MARY E. RODMAN RECREATION CENTER RENOVATION

CONTRACT NO. 20814

ADDENDUM NO. 1

For: SPECIFICATIONS AND DRAWINGS

VCT = VINYL COMPOSITION TILE
CONC. = CONCRETE
RB = RUBBER BASE
ACT = ACOUSTIC CEILING TILE
PNT = PAINT
CT = CERAMIC TILE
GWB = GYPSUM WALL BOARD

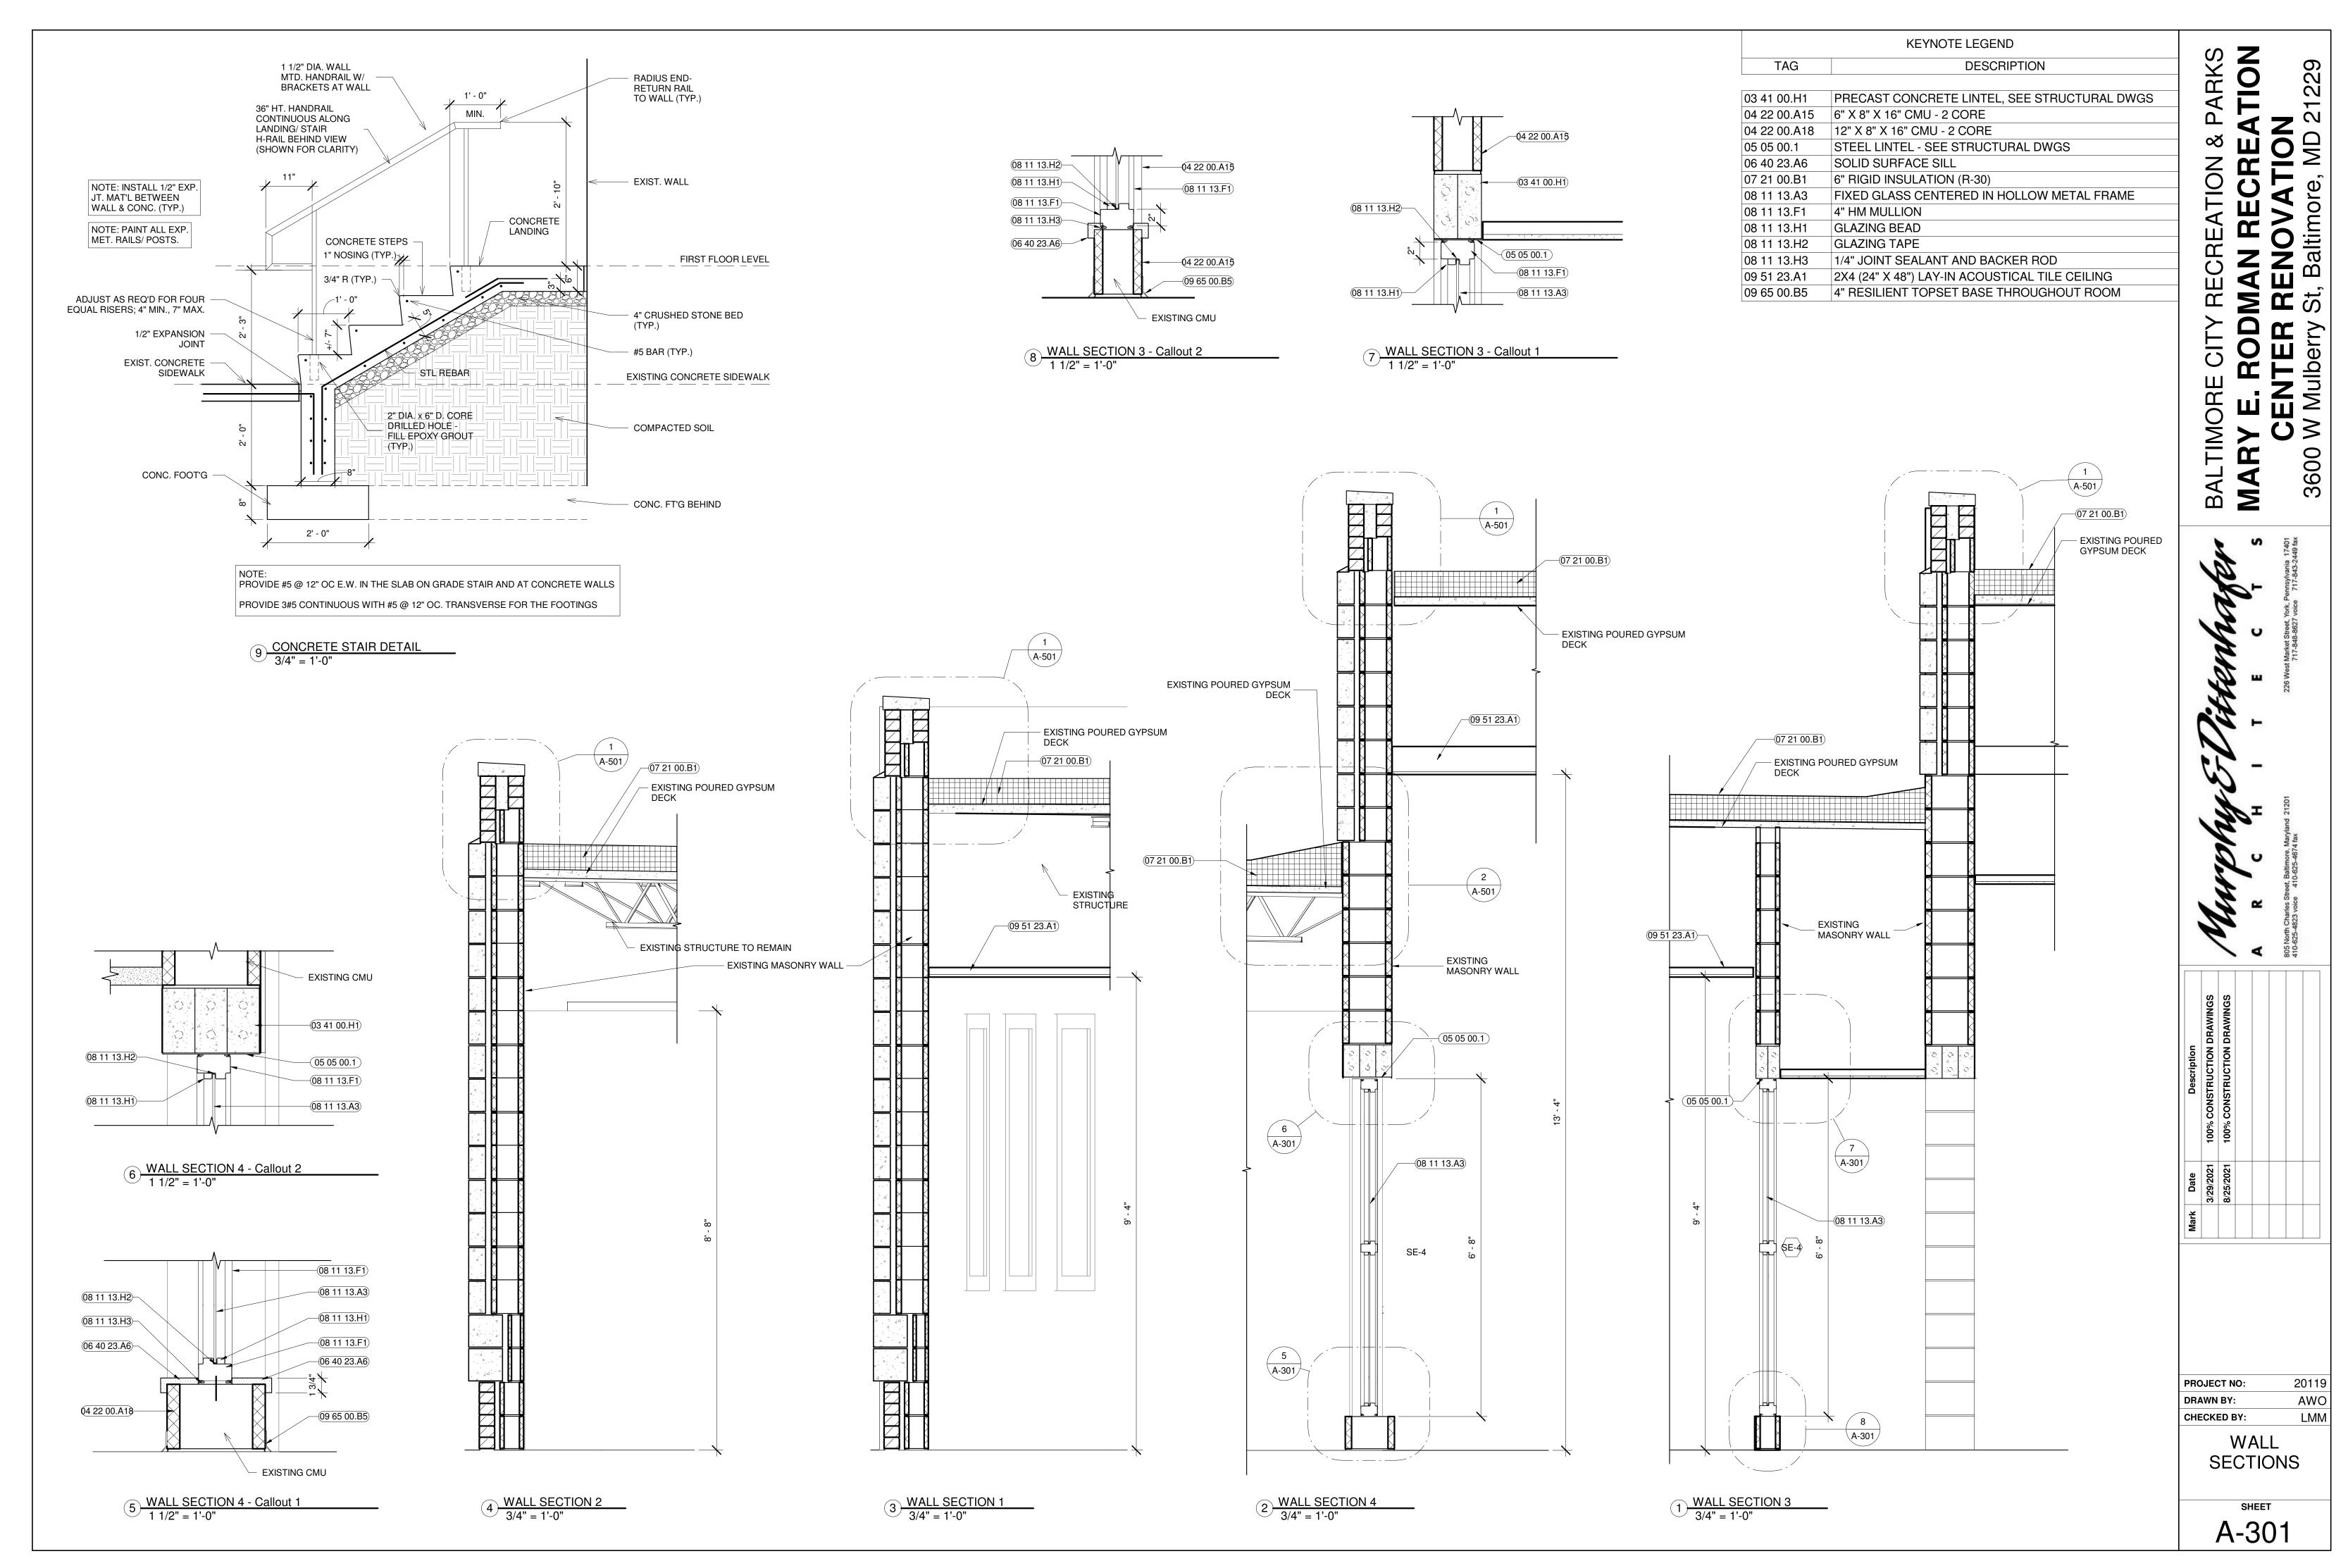
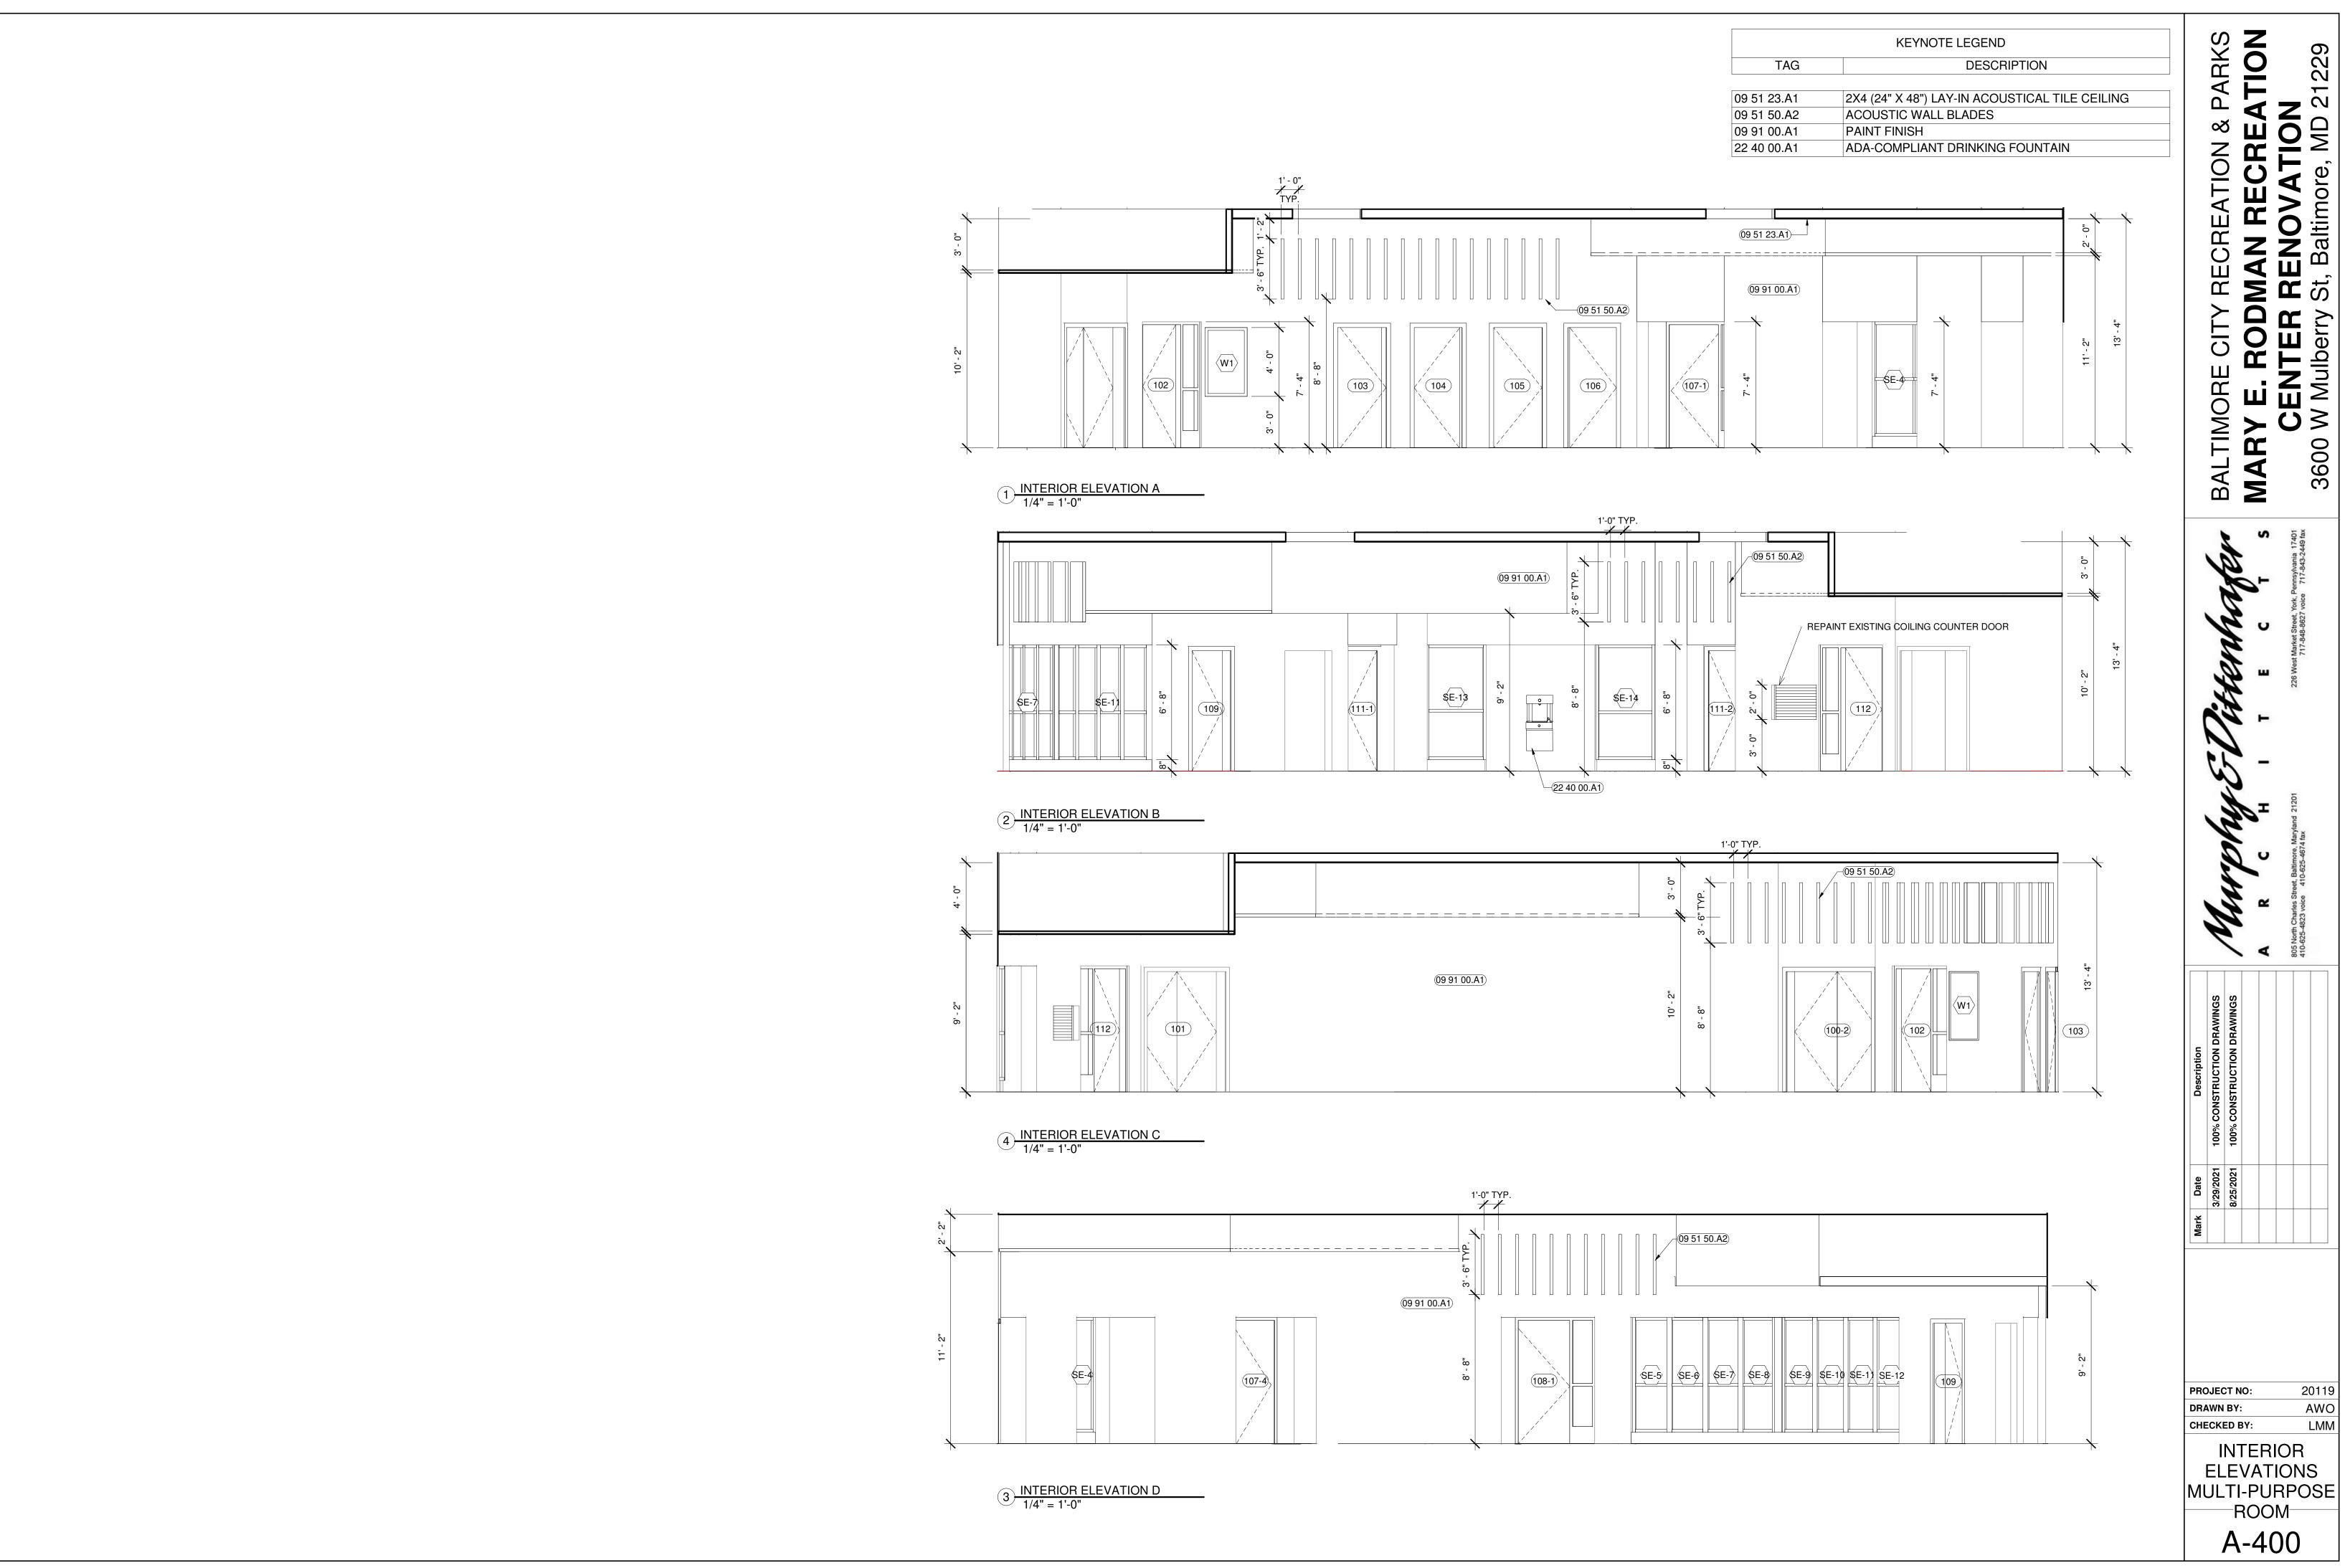
2.6 Sheet A-104, Finish Plans

- 1. Room Finish Schedule revised to Walk off mat, ACT-1 and PNT in the Vestibule.
- 2. Room Finish Schedule revised to GYP in 102A, and 103
- 3. Room Finish Schedule revised to remove Exec. Office Room 102 A
- 4. Room Finish Schedule revised to show rooms 404 and 405

4) Sheet A-101 shows Storage Room #404 and Storage Room #405, yet these rooms are not included on Sheet A-104's Room Finish Schedule. The Finish Plan on sheet A-104 D does show VCT flooring to be installed in Rooms #404 and #405. Can you confirm that the existing flooring is to be replaced with new VCT and that the ceiling finishes and wall paint is to be existing to remain for these two rooms?

7) There are several discrepancies between the Room Finish Schedule and the drawing's plans that need to be clarified. The Vestibule finish schedules states VCT floor finish and ACT-1 ceiling finish while 1/A-104 show walk-off mat flooring and 1/A-107 shows both gypsum board ceiling and ACT. The Finish schedule says that the Vestibule walls are ETR, yet the proposed new CMU should likely have a painted finish and the existing exterior walls to be butted and becoming interior walls will likewise require new paint. For both rooms #102A Executive Toilet and 103 ADA Restroom, the finish schedules states ACT-1 ceiling finish, but 1/A-107 shows gypsum board ceiling. Please clarify the desired finish for each of these discrepancies.

Answer: Storage Rooms 404 and 405 have been added to the finish schedule. These rooms are to receive new VCT flooring. Confirmed: ceiling finish and wall paint is existing to remain for these two rooms.

Answer: Vestibule floor to be walk off matt, Vestibule ceiling to be 2x2 ACT, Vestibule interior walls of new CMU to be painted. Room #102A ceiling to be GWB, Room #103 ADA Restroom to be GWB
